ADDENDUM NO.: 2

Description: Furnish, Deliver and Install Audio-Visual Equipment

Project: CUNY College of Staten Island

Specifics of the Addendum: Answer questions received during the RFI period and Extend the Bid Opening Date.

Seal & Signature: _____ DASNY Project No: **3453509999**
Drawing Number: _____
TA-803.00
Drawing of _____

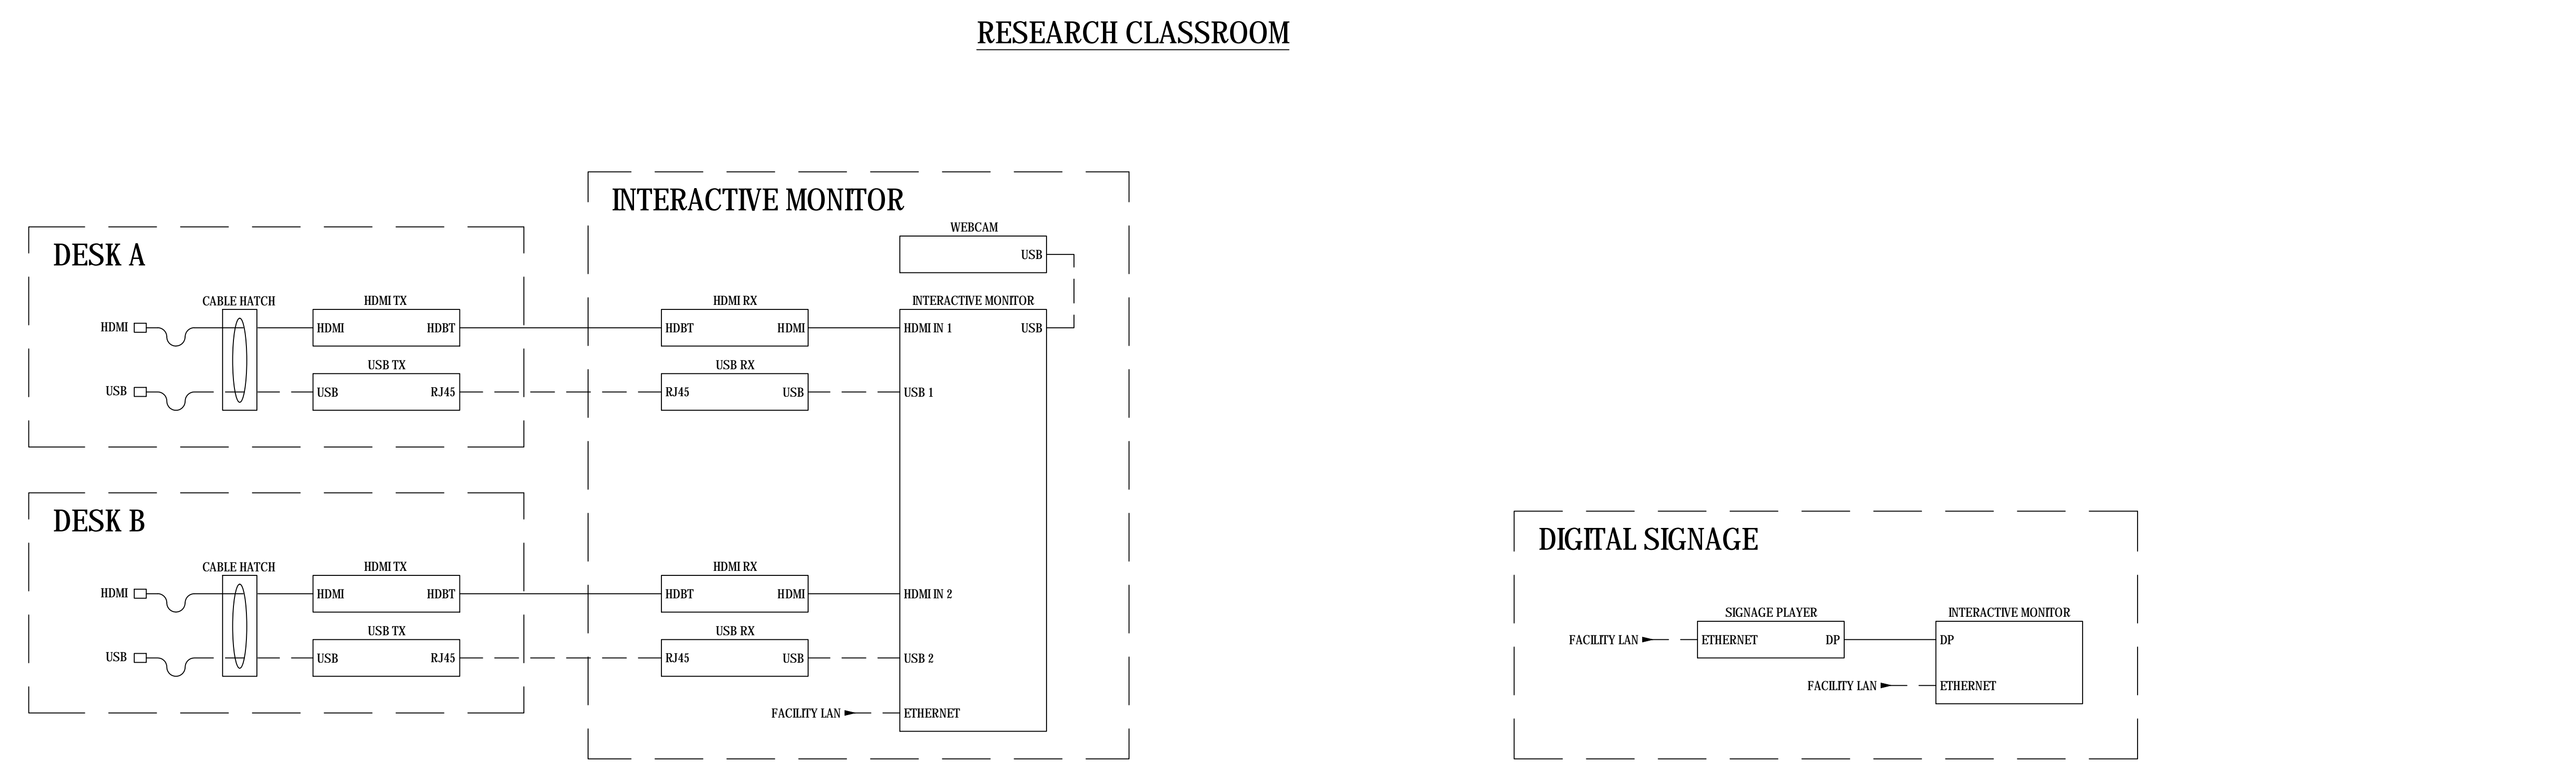
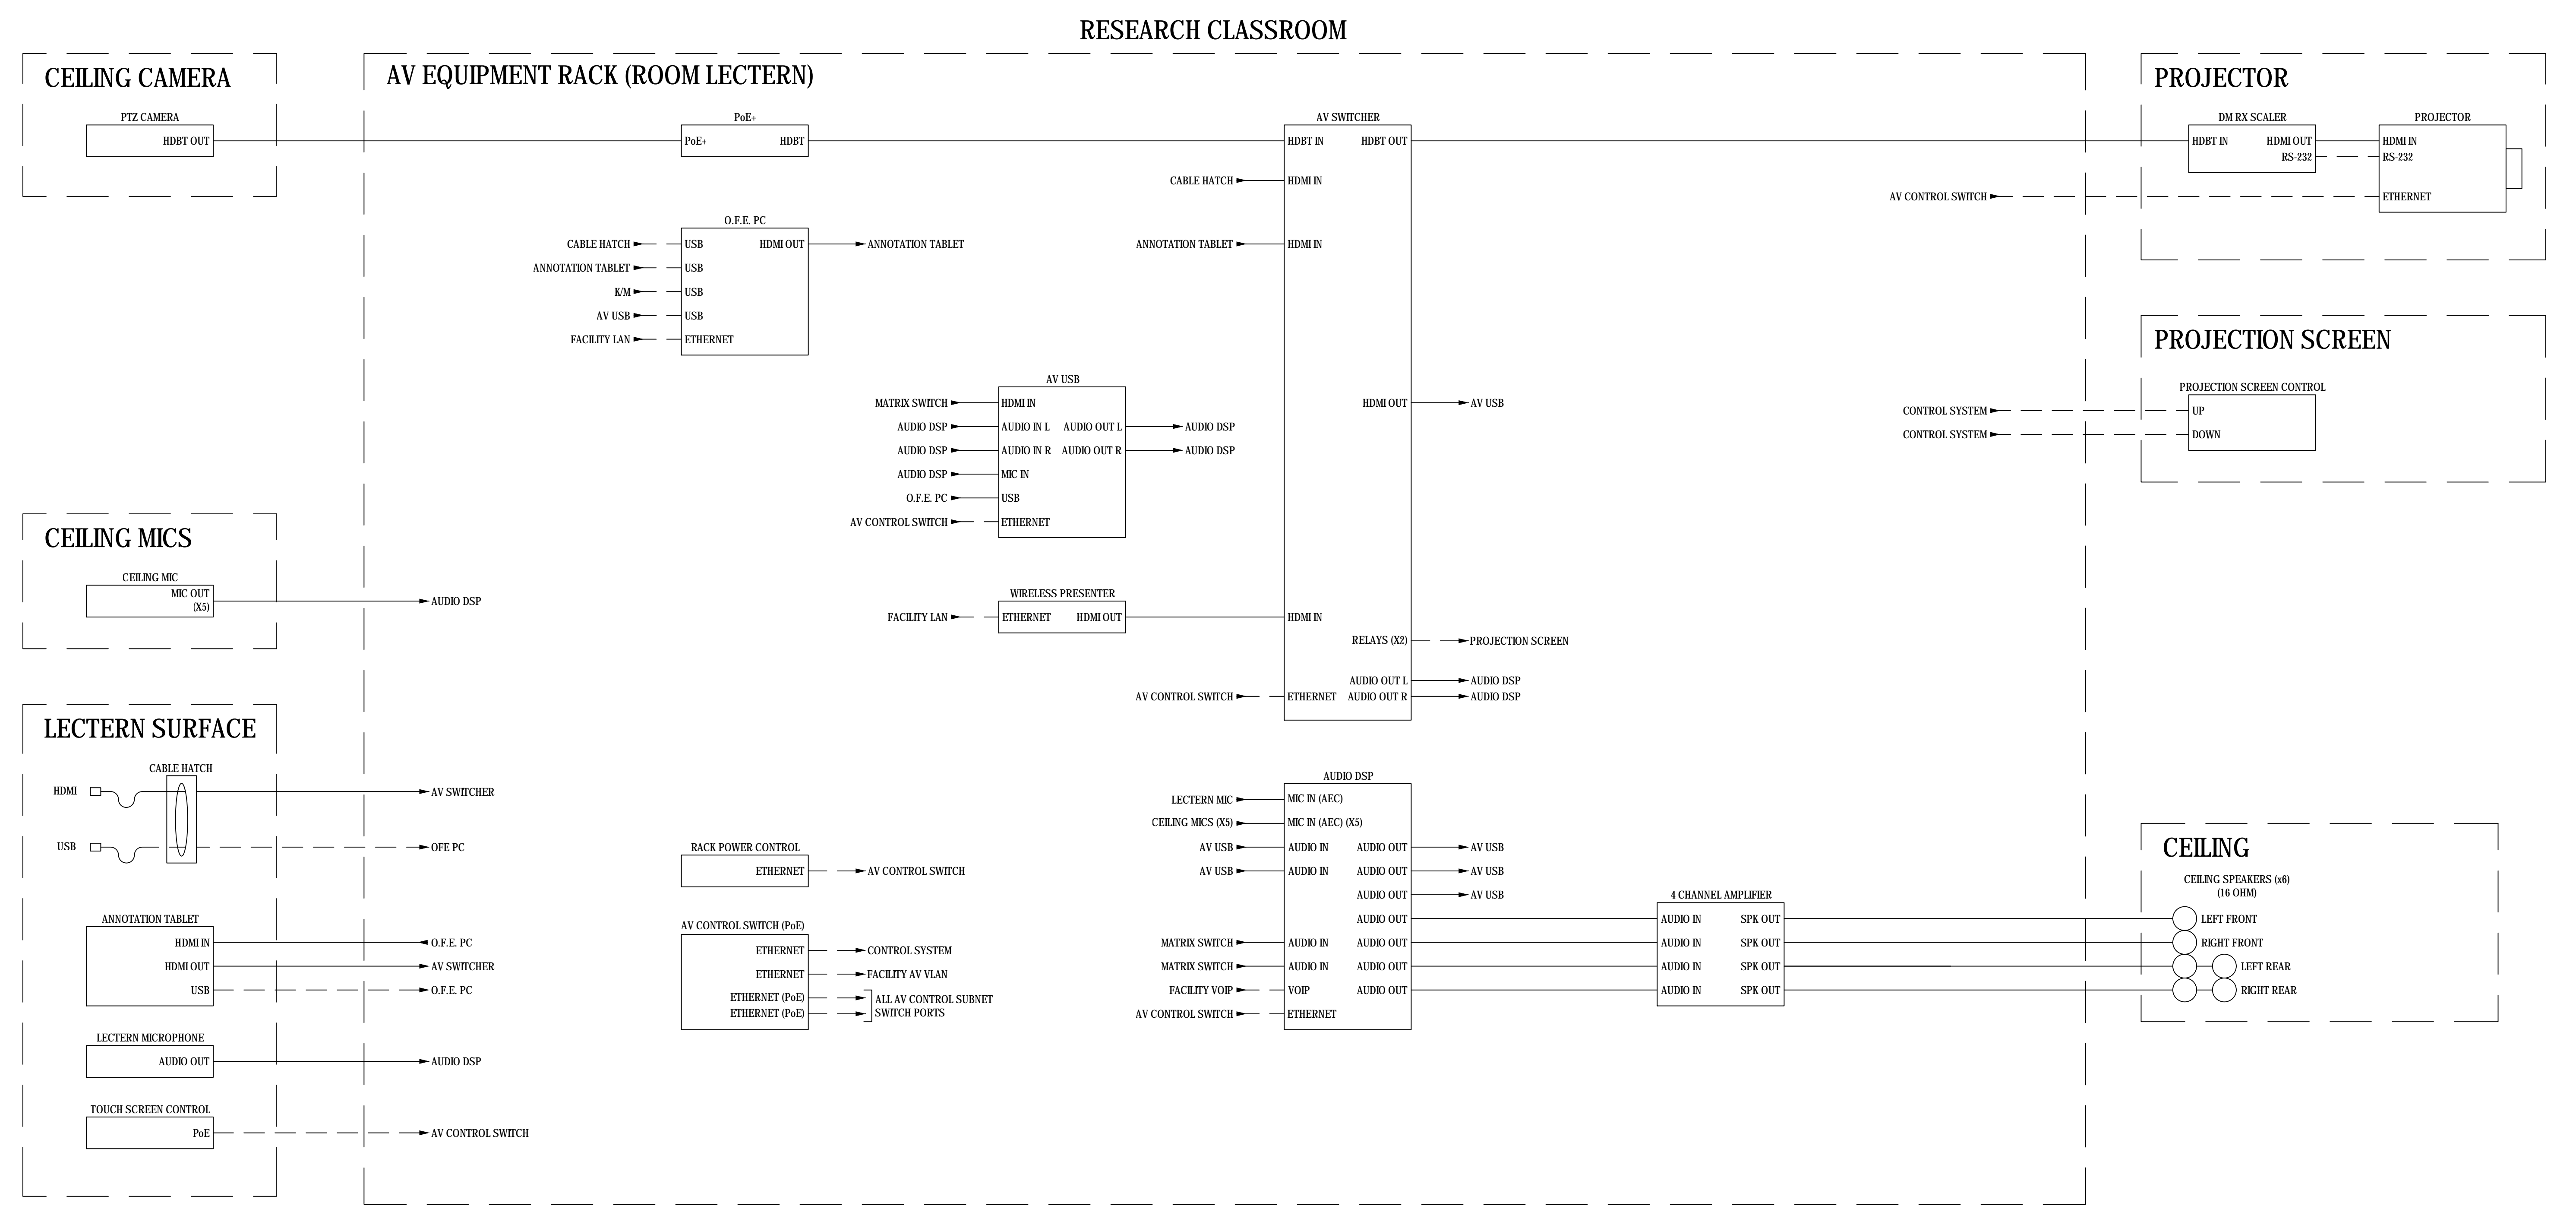
20. Q: Drawing TA-803 Room 136 Research Classroom: Does the AV Contractor scope include furniture such as lectern? If so, please supply details such as name of manufacturer and model number.
A: Supplied by furniture vendor: Nucraft AVFL-3245-CP-PE-FSUPD-MCSH- GB High Tech Lectern.

Seal & Signature _____ DASNY Project No: **3453509999**
 Drawing Number
TA-804.00
 Drawing of _____

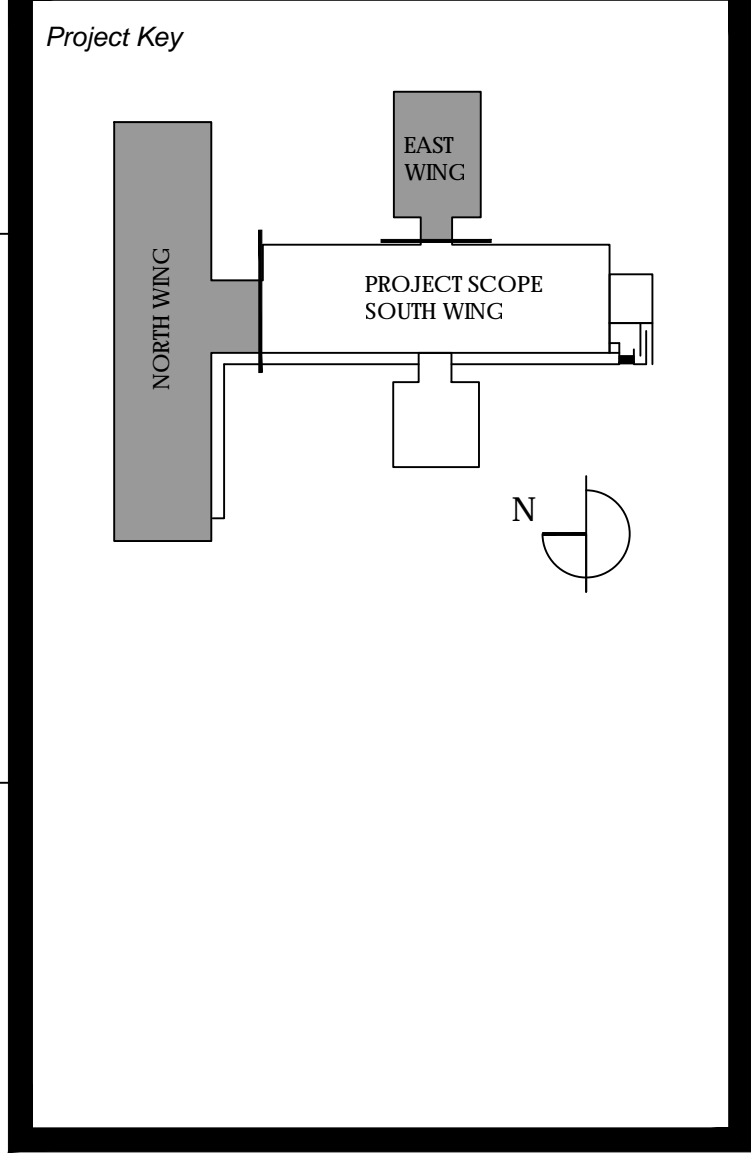
15. Q: The equipment list shows a quantity of three for the Extron Cable Cubby, however the drawing TA-804.00 Mini Lab and Group Study also show a Cable Cubby so should the quantity be increased to 7? If so, please confirm correct quantity.
